**Pacific Gas and
Electric Company**
Power Generation
Fossil Plant Construction

Gateway Generating Station
3225 Wilbur Ave.
Antioch, CA 94509
(925) 459-7200

Subject: Gateway Generating Station (Docket 00-AFC-1C)
Petition for a Change to Gateway Generating Station Project Inlet Chiller System

Petition for a Change to the Gateway Generating Station Project Inlet Chiller System

Figure 2.1-1, page 1 of 4

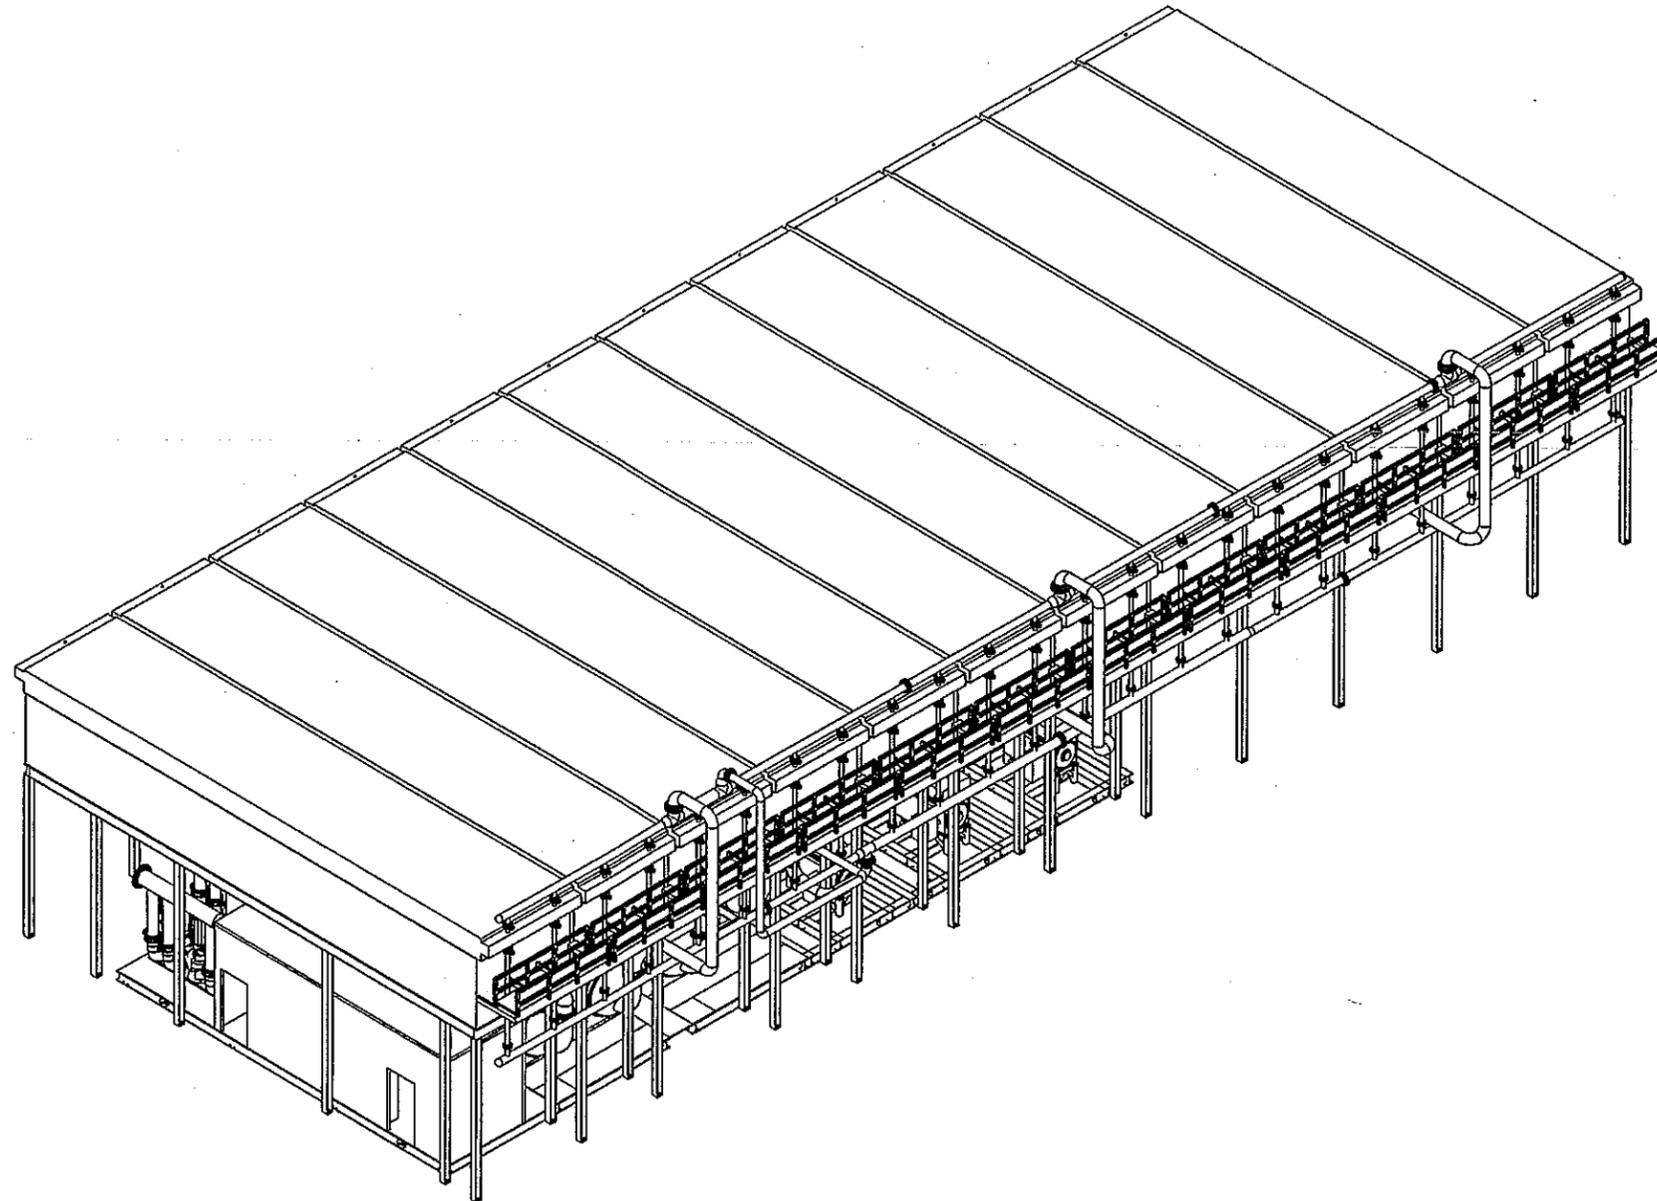
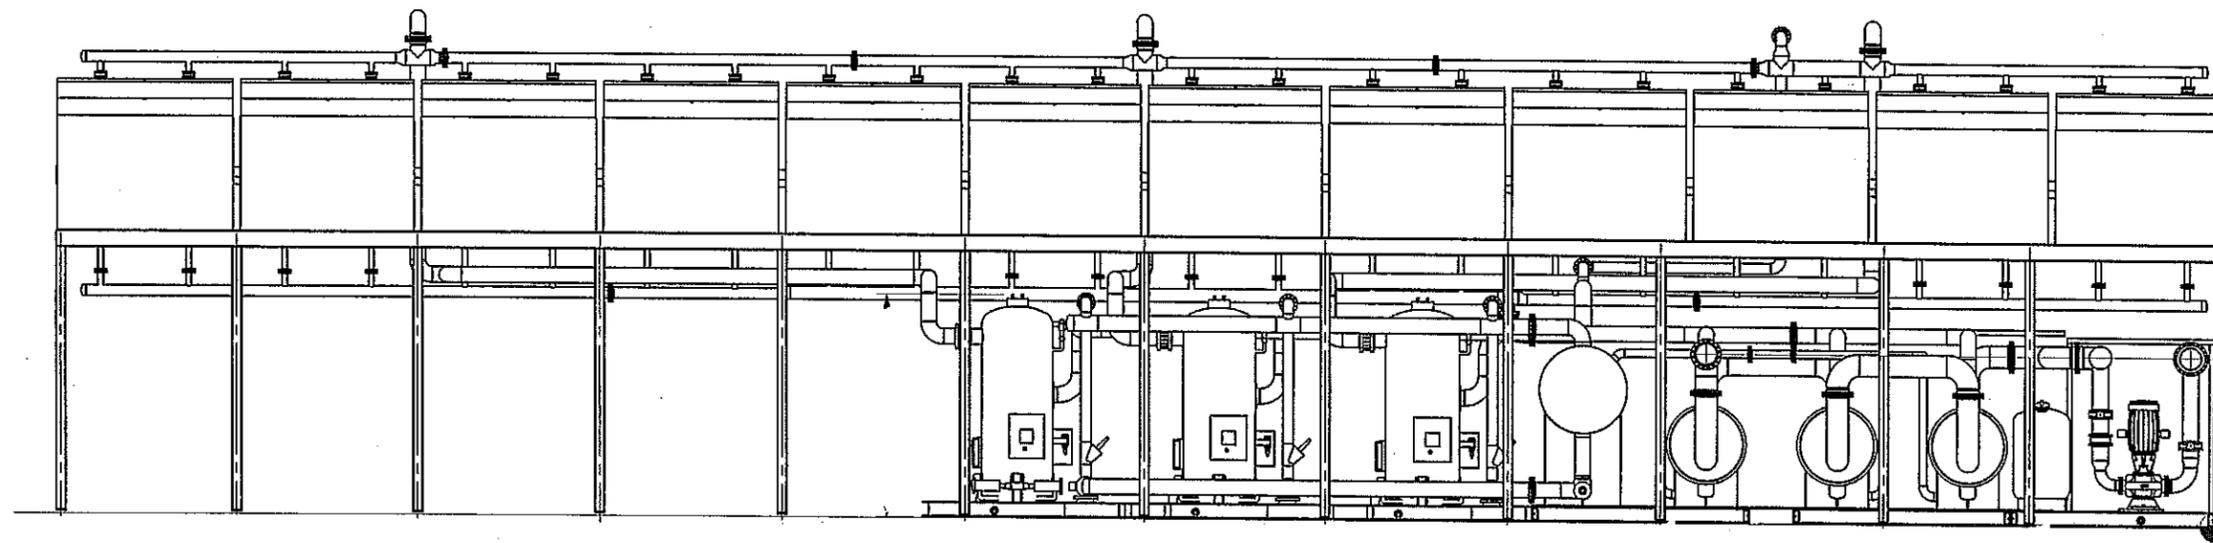
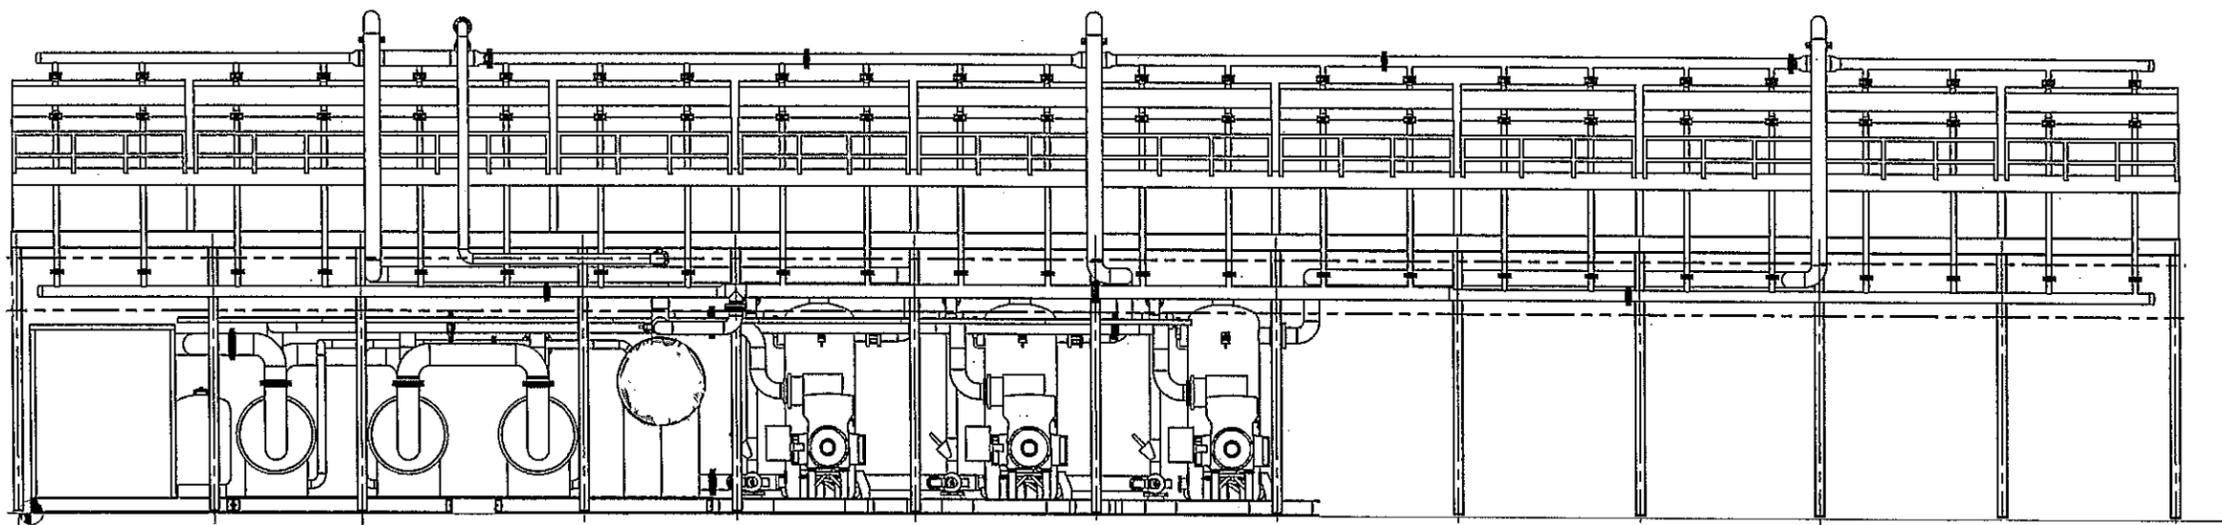
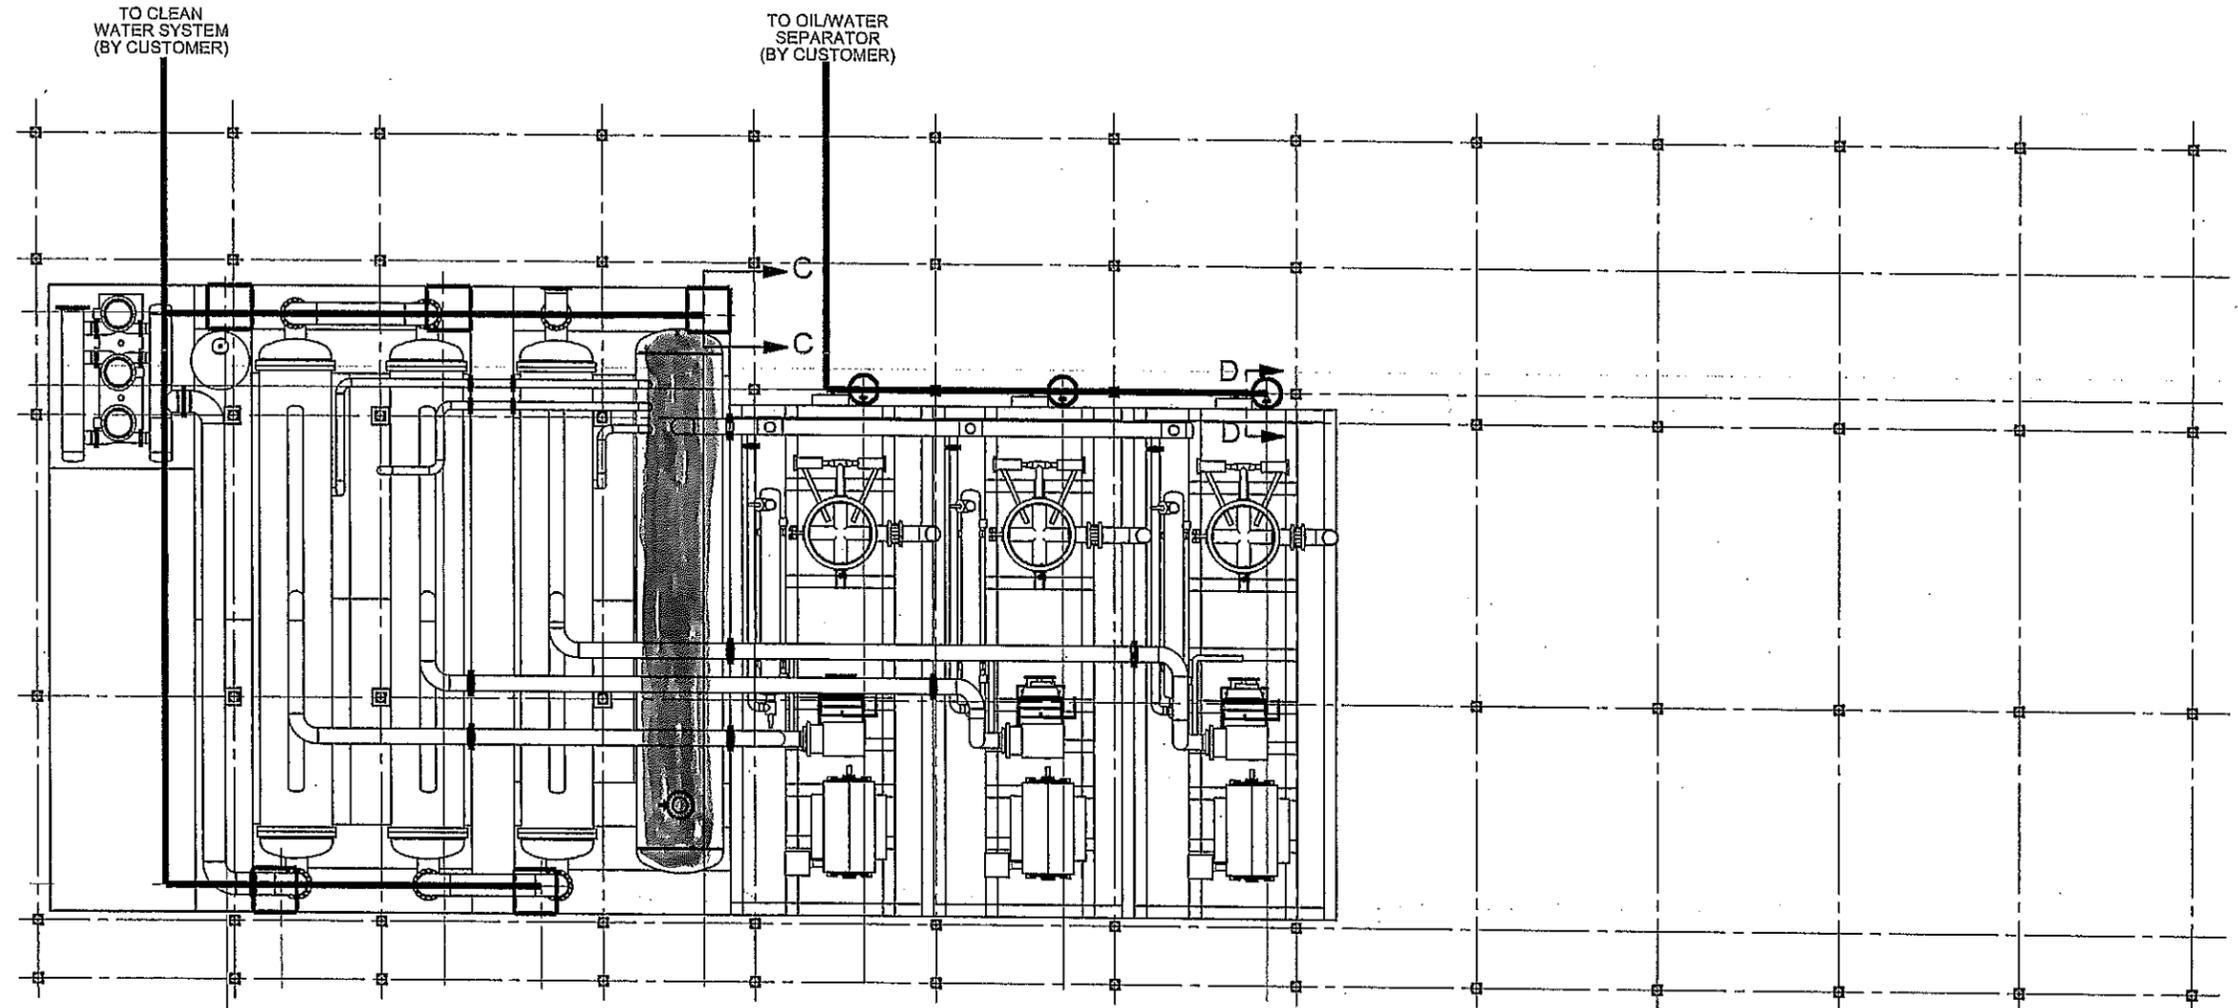
PG&E is proposing to change the refrigerant that will be used in the inlet chiller system from R134A to anhydrous ammonia. (The inlet chiller system was approved by the CEC on August 1, 2007, as part of PG&E's dry cooling amendment, to replace the original evaporative cooling system.) The electric chiller system is designed to reduce the inlet air temperature to the combustion turbine to 50 °F by drawing the inlet air across cooling coils containing anhydrous ammonia chilled water. A general layout arrangement for the chiller system is shown in Figure 2.1-1 and a process flow diagram is shown on Figure 2.2-2.

The proposed chiller system selected is an anhydrous ammonia-based mechanical chiller unit. The chiller system will comprise two subsystems, a chilled water system and a refrigerant system. The chilled water system is a closed-loop system where chilled water will be circulated through cooling loops in the combustion turbine's inlet air duct. After passing through the inlet air duct cooling loops, the water will be pumped to one of three shell and tube heat transfer vessels. The second system is the refrigerant loop, consisting of three screw compressors, ammonia condensers, a 7,100 gallon ammonia receiver vessel, three heat transfer vessels, and a lubricating oil system with a fin-fan cooler.

During the design of the chiller system, the manufacturer evaluated six common refrigerants and concluded that the most efficient refrigerant for the Gateway Generating Station project inlet chiller system is anhydrous ammonia. The R-134A refrigerant was not selected due its lower efficiency and the need to install multiple R-134A systems to achieve the approximate capacity of the ammonia-based system. The R-22 refrigerant was not selected due to a combination of lower efficiency of this type of system and environmental considerations. The option of using propylene as a refrigerant was also eliminated due to its lower efficiency and the inherent fire and explosion risk associated with this material. Therefore, PG&E selected an ammonia based system, while recognizing that anhydrous ammonia has inherent risks as well.
